ENGINE - ELECTRICAL POWER - PROVIDE A NEW IDG OIL COOLER OIL INLET CONNECTOR SUPPORT
BRACKET - CATEGORY CODE 6. - MOD.ENG-24-0005

V2500-ENG-24-0005

SERVICE BULLETIN

Location of support bracket
Fig.1

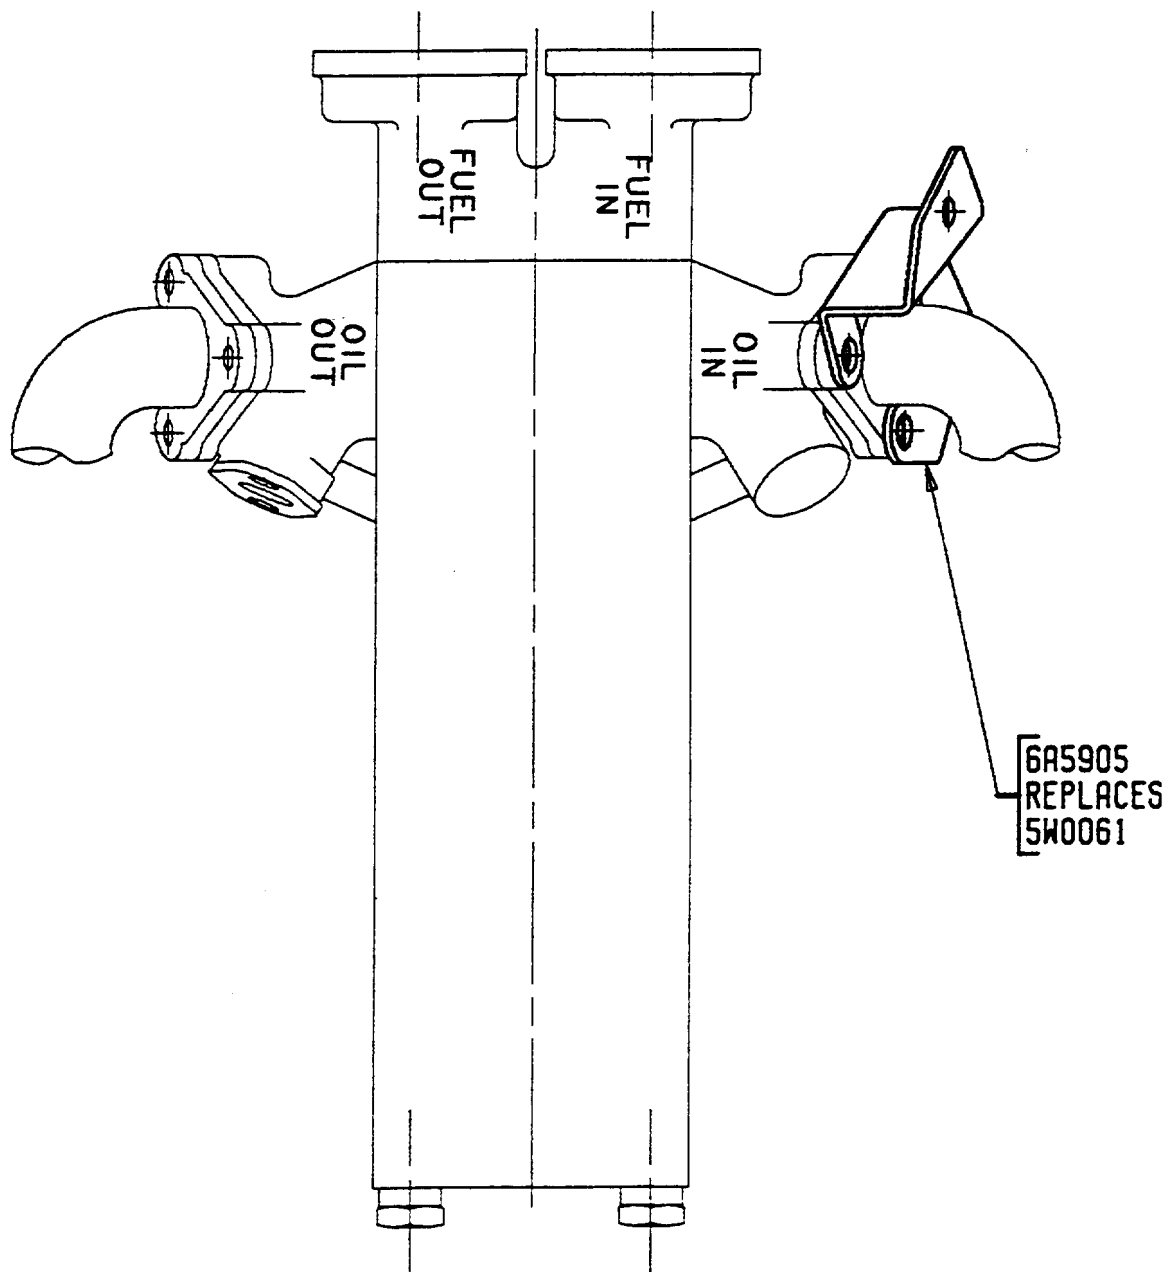
It has been found on build that a foul may occur between the support bracket for Clipping Points 0317 and 0917 and the I.D.G. oil cooler oil inlet tube adaptor.

The support bracket was designed to suit the forged adaptor but a foul may occur with the machined adaptor due to its different profile.

This Service Bulletin introduces a new support bracket for clipping points 0317 and 0917 with increased clearance for machined oil inlet tube adaptors.

- (1) Install the new 6A5905 bracket on to the IDG oil cooler oil inlet tube adaptor in accordance with the approved procedure, Reference (1) Chapter/Section 72-00-32, Installation-03, Config-1. Refer to Figures 1 and 2.
